# Pole Attachment Violations

Nolin RECC System

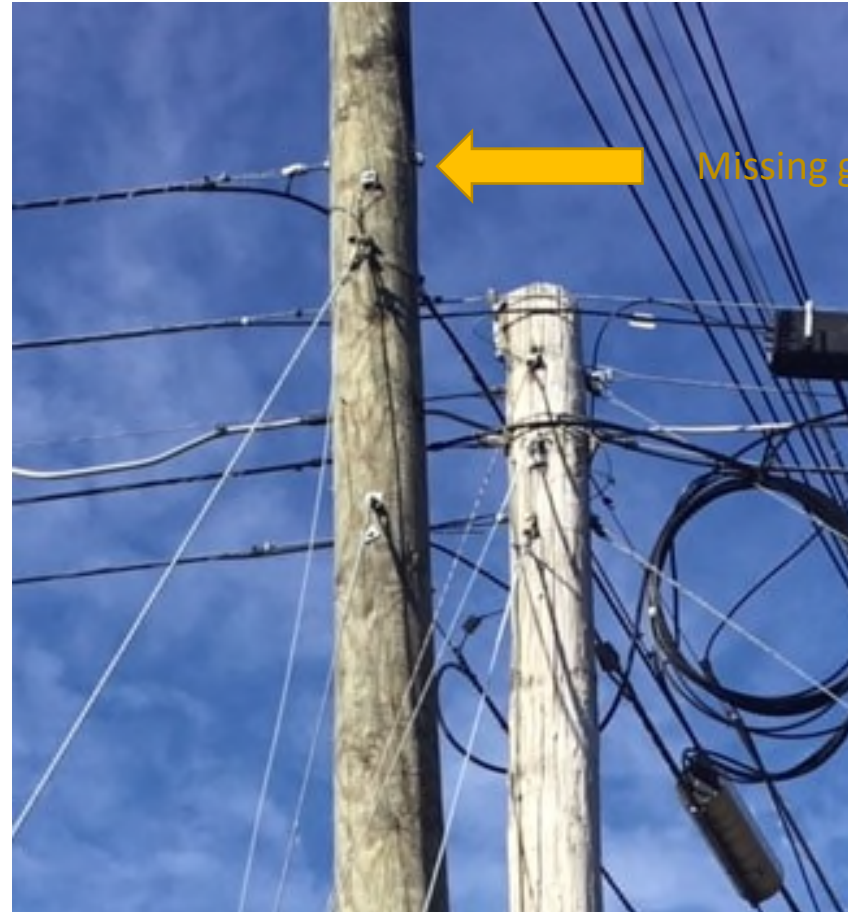
I-65 Crossing – New cable attached to existing midspan because of ground clearance issue
